Meeting Agenda

Franklin Municipal Planning Commission

Thursday, May 28, 2020

C2.1

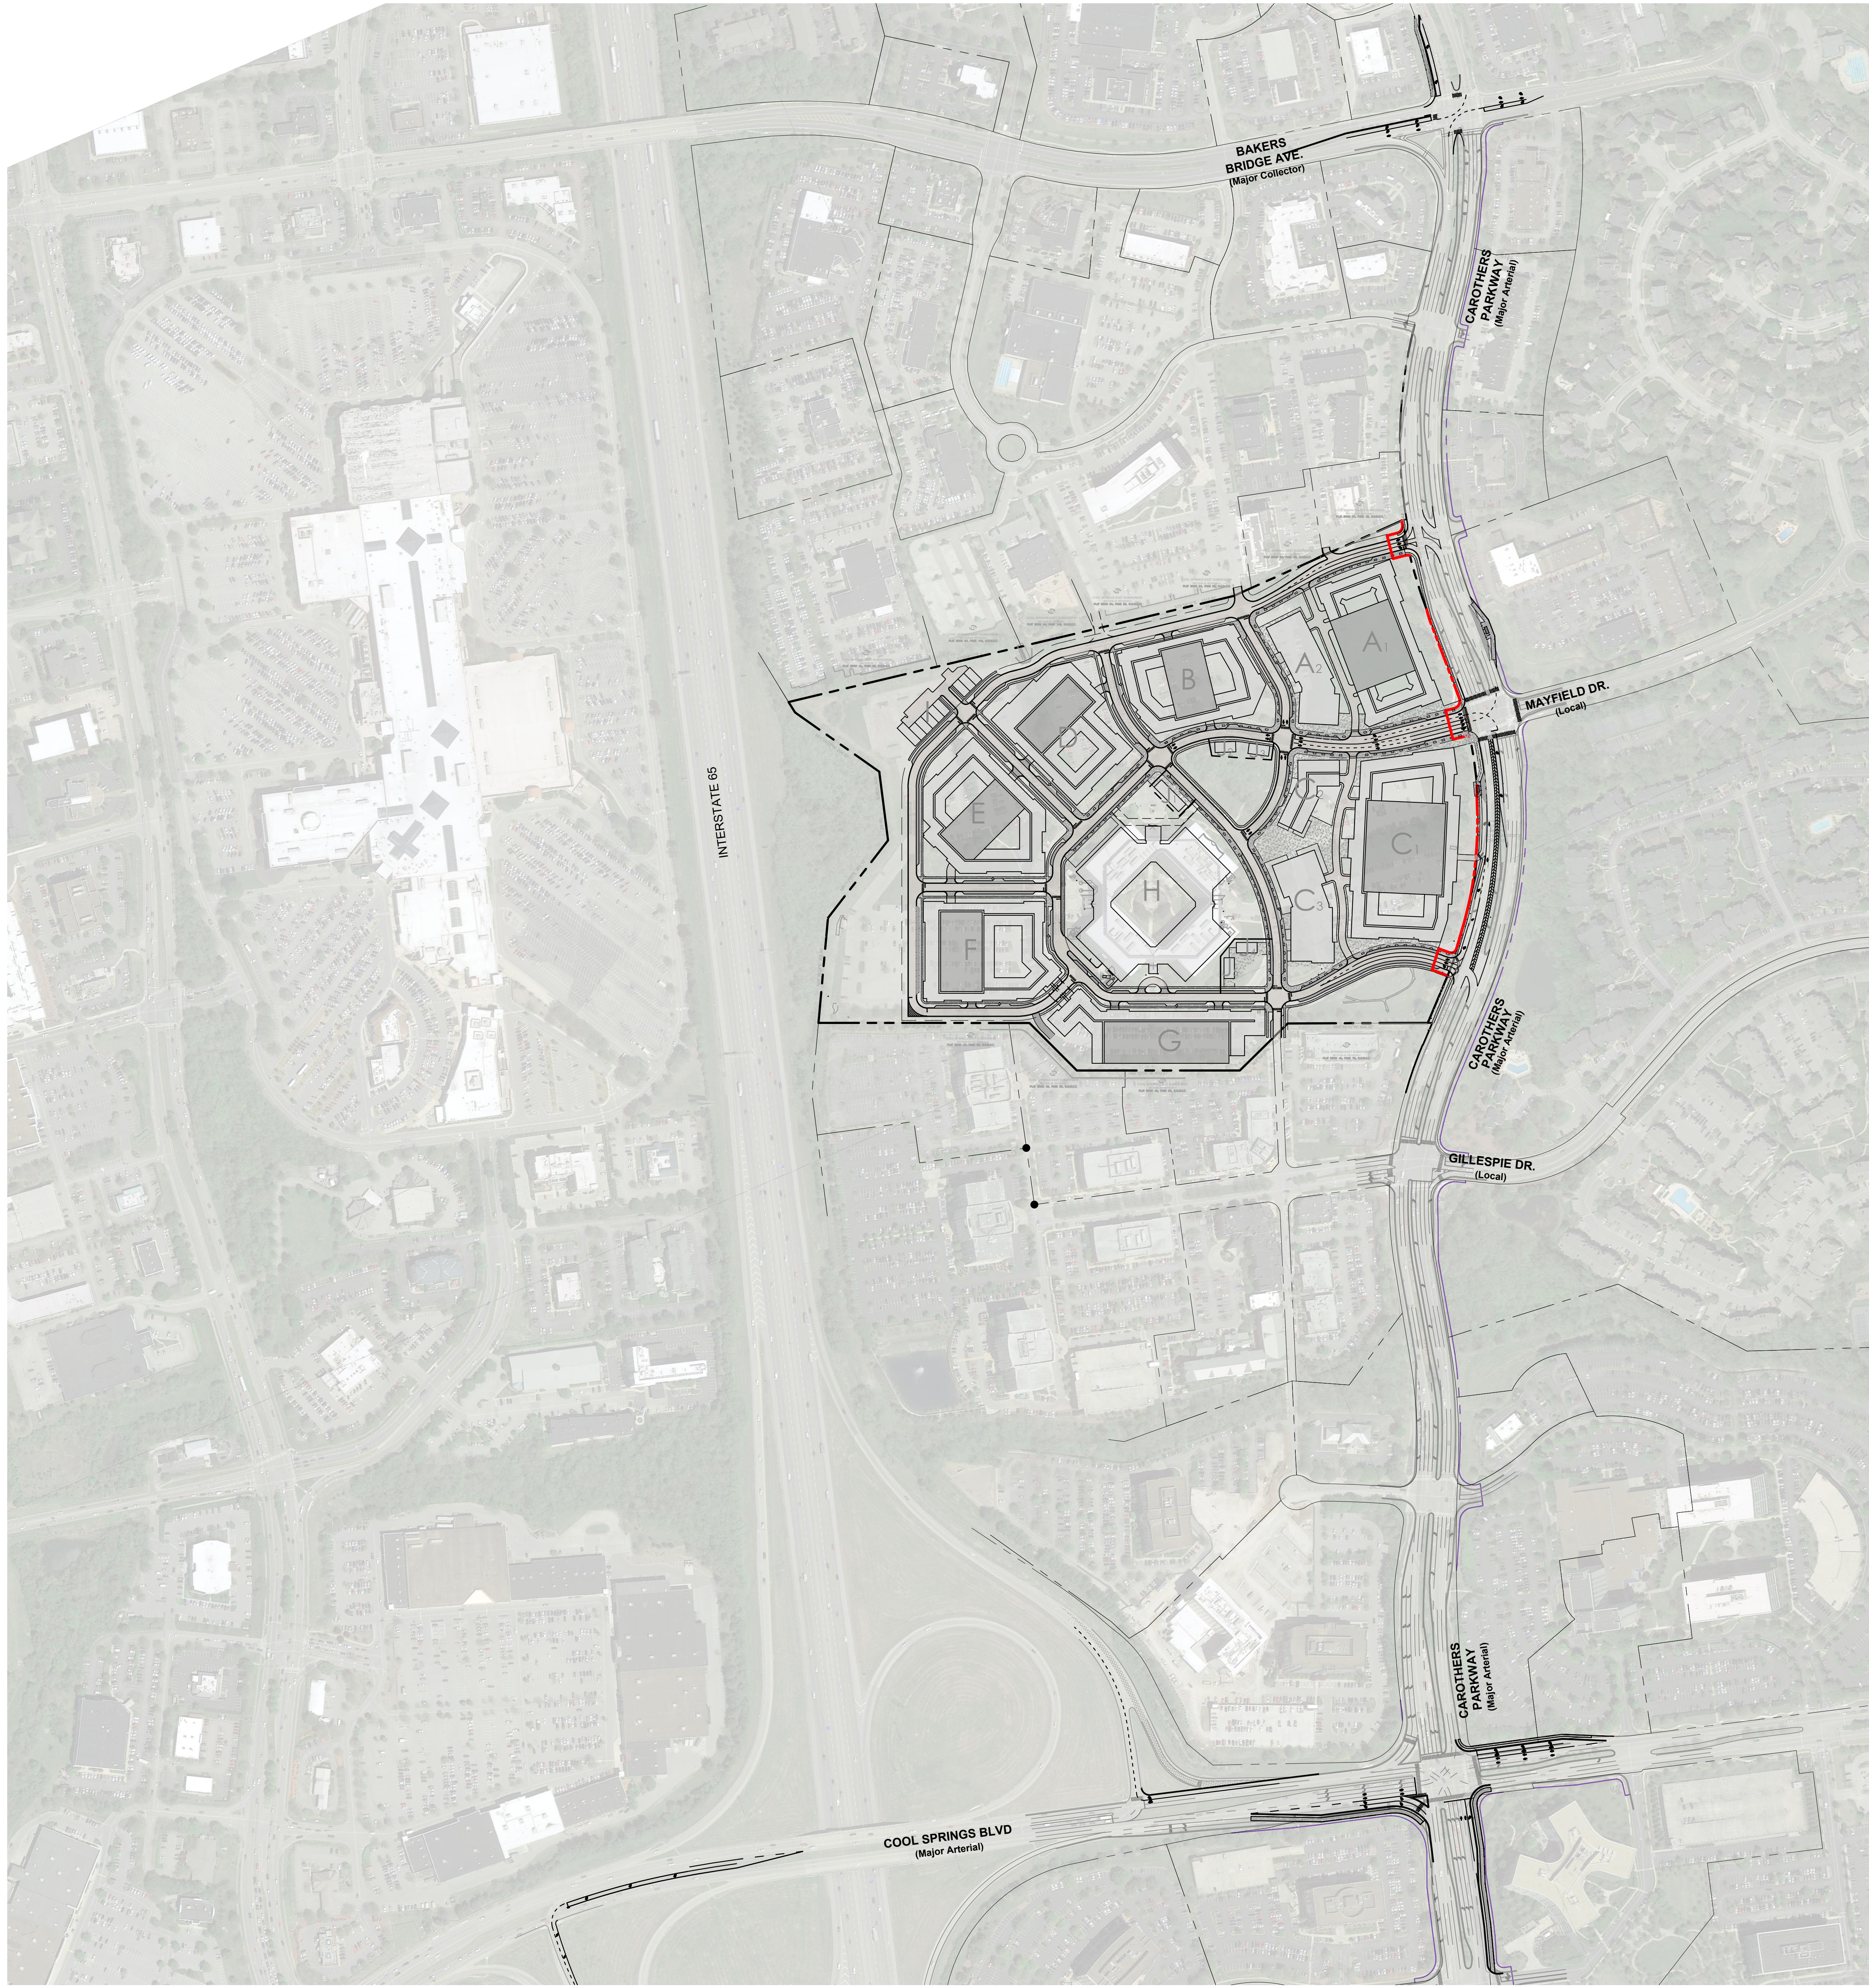
joe.marlo@franklinton.gov Applicant shall revise notes on C2.0, C2.1 and potentially other sheets to refer to connectors instead of habitable units.

However, the "bridge units" are specifically identified as habitable on sheet C2.0:

C6.3

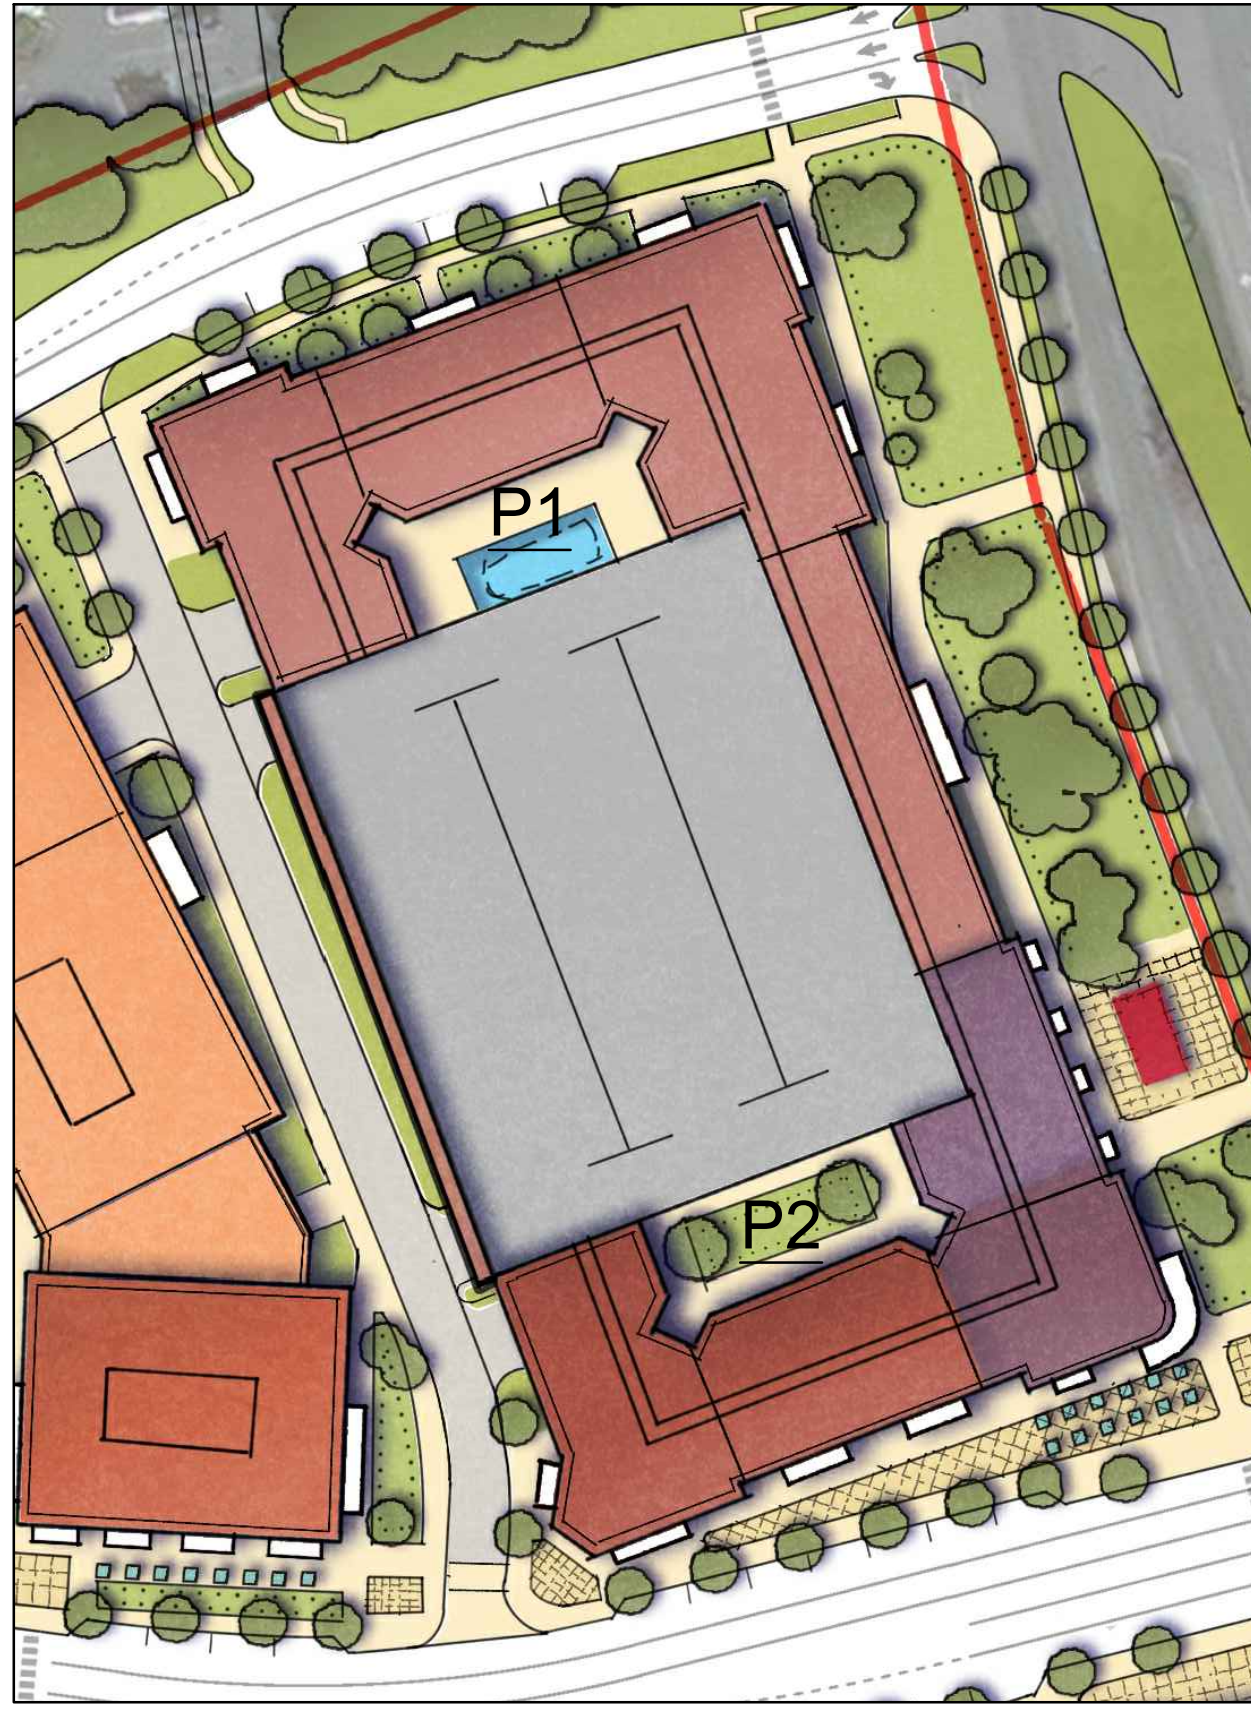
The offset agreement has been submitted for review. The applicant shall remove Sheet C6.1 to avoid conflicts and confusion. The improvements shall be discussed further with FMPC and the BOMA.

50. Long Term Maintenance Plan

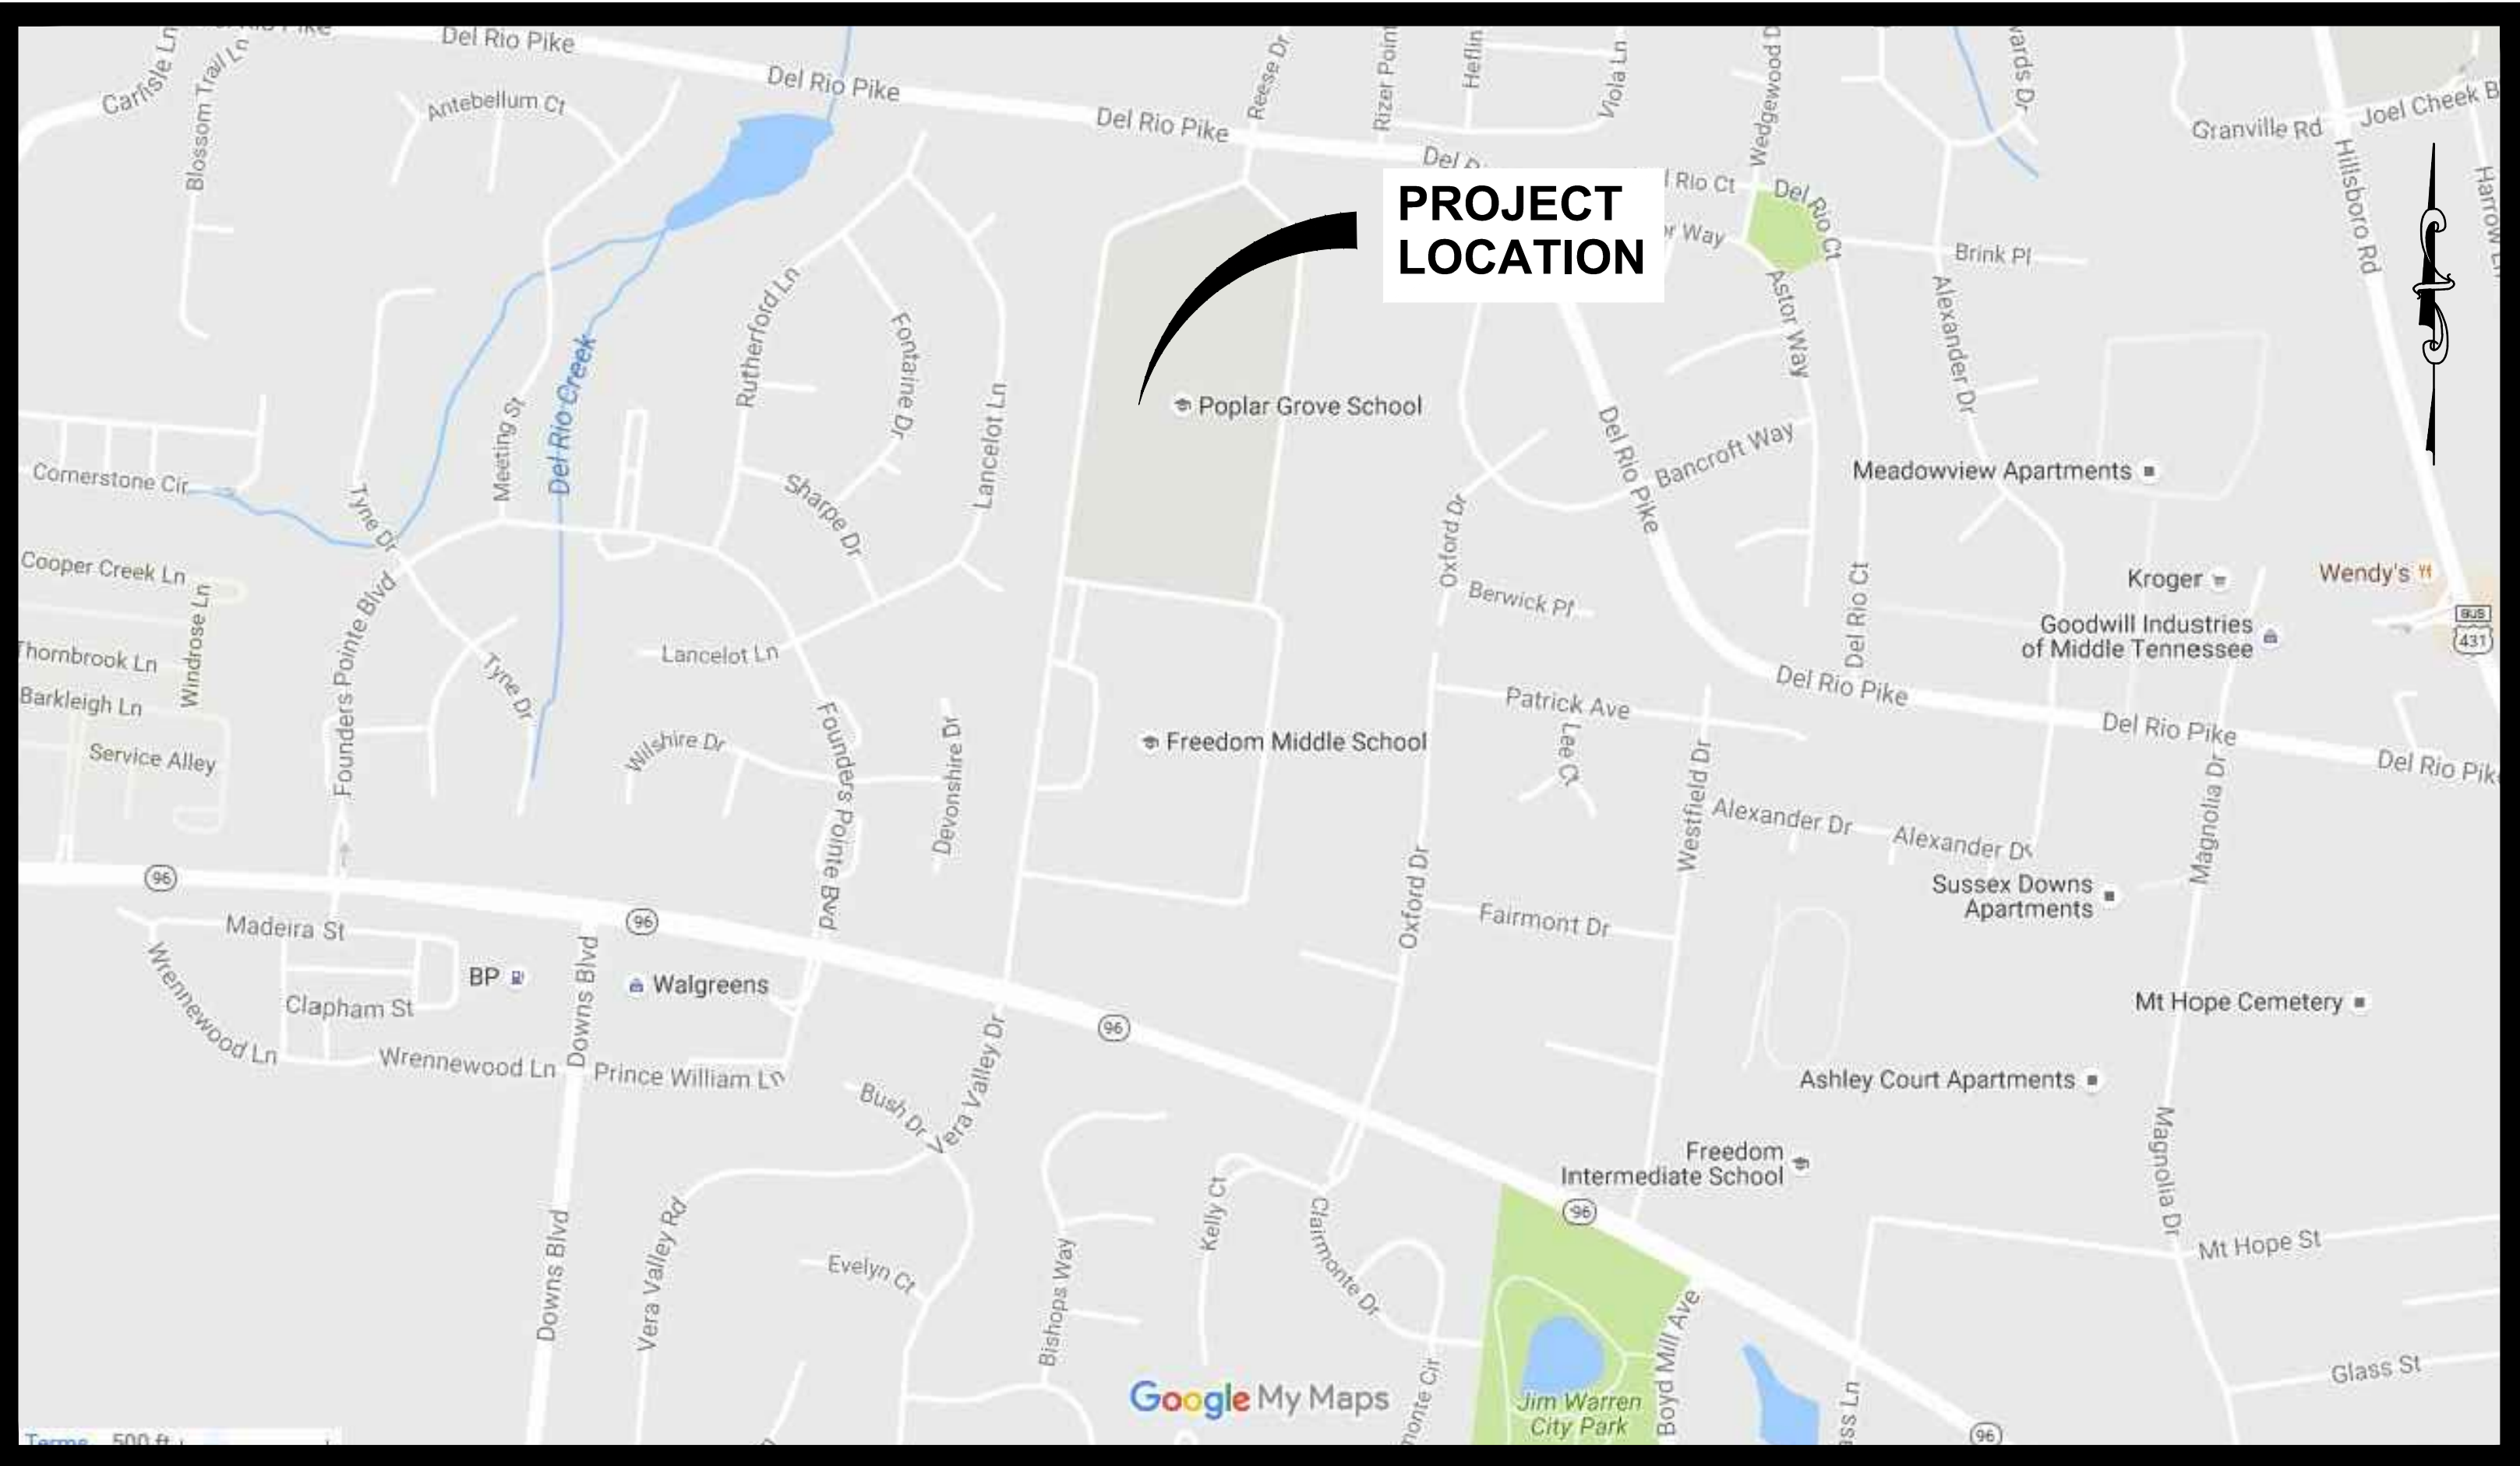
jeff.willoughby@franklintn.gov Please ensure all boxes are filled in on the LTMP form page 1
Include storm sewer inspection sheet
